## **PRE-APPLICATION CONFERENCE**

1810-1838 N. Argyle St.  
Property ID: R196150, R196149

CASE FILE	EA 21-040329 DA
WHEN	Thursday, June 3, 2021 @ 1:30 PM <i>(This is the hearing start time –see Commission agenda for estimated project start time.)</i>
WHERE	<b>ONLINE:</b> Link to drawings is available at <a href="http://www.portlandoregon.gov/bds/dcagenda">www.portlandoregon.gov/bds/dcagenda</a>
HOW	<b>TO COMMENT:</b> Follow instructions on the Design Commission agenda or email the planner at <a href="mailto:Grace.Jeffreys@portlandoregon.gov">Grace.Jeffreys@portlandoregon.gov</a>
REVIEW BY	DESIGN COMMISSION
PROCESS	A <b>Design Advice Request</b> is a voluntary review process that allows the Commission to provide early feedback on a development proposal, prior to the required land use review
PROPOSAL	<p>Design Advice Request meeting for a proposed new eleven-story, multi-family building in the Kenton Plan District. The proposed modular constructed, mass timber structure will provide approximately 300 residential units and 10,000 SF of user amenities and bicycle parking. 100% of the units will be offered at 60% Average Median Income (AMI), as a mix of two-bedroom, one-bedroom, and s

### 3. Ground floor treatments.

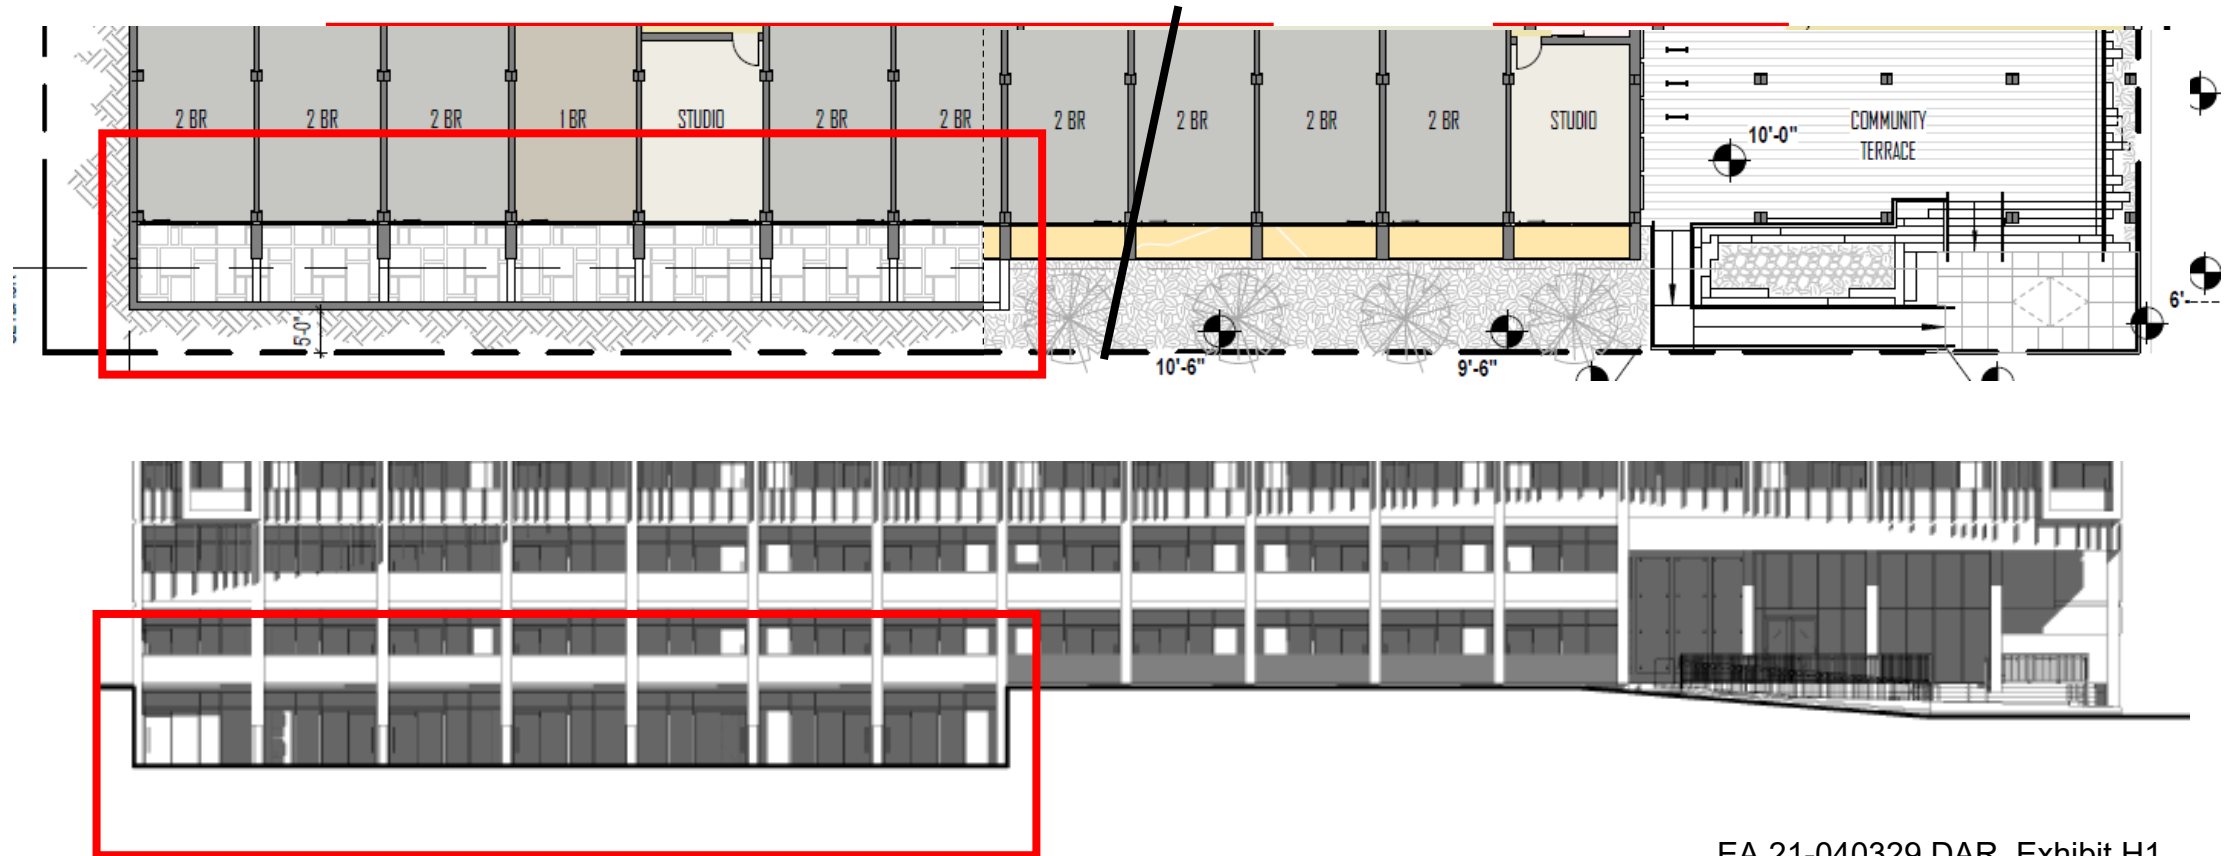
- South elevation – adjacent slope, landscaping and condition at basement units
